MEMORANDUM

Subject: 910-916 W. ANDERSON LN. – Zoning Transportation Analysis

The Transportation Development Services (TDS) Division has reviewed the February 6, 2024, "910-916 W. Anderson Ln. Zoning Transportation Analysis", prepared by LJA. The proposed land uses consist of residential, retail, hotel, and office buildings. The site is located at 910-916 W. Anderson Lane, 1100 & 1012 & 1012 1/2 W. Anderson Lane, 8000 Research Blvd. in Austin, Texas as depicted in Figure 1 below.

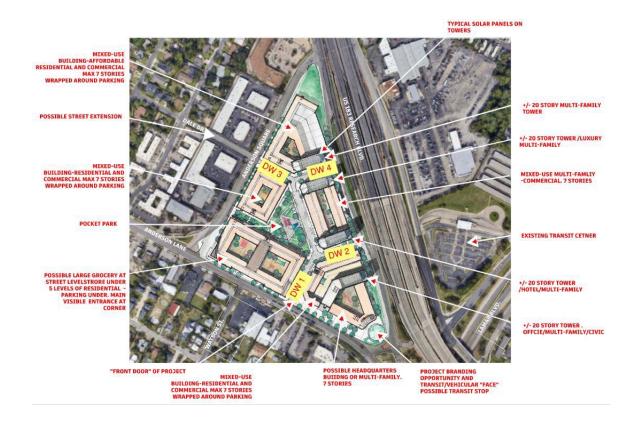
Site access will consist of four driveways - one on Anderson Square, one on West Anderson Lane, and two on Research Blvd. The development is anticipated to be constructed in one phase to be completed in 2028.

- 1. Provide no more than two driveways proposed along Research Blvd. Both driveways will operate as right-in, right-out. Final approval will be given by TxDOT as the site is directly accessing TxDOT roadways.

- 2. Provide no more than one driveway along W. Anderson Ln. This driveway will operate as full purpose. The driveway will be further reviewed during the site plan process by appropriate City departments and will be subject to adherence with the Transportation Criteria Manual (TCM).

- 3. Provide no more than two driveways along Anderson Sq. This driveway will operate as full purpose. The driveway will be further reviewed during the site plan process by appropriate City departments and will be subject to adherence with the Transportation Criteria Manual (TCM).
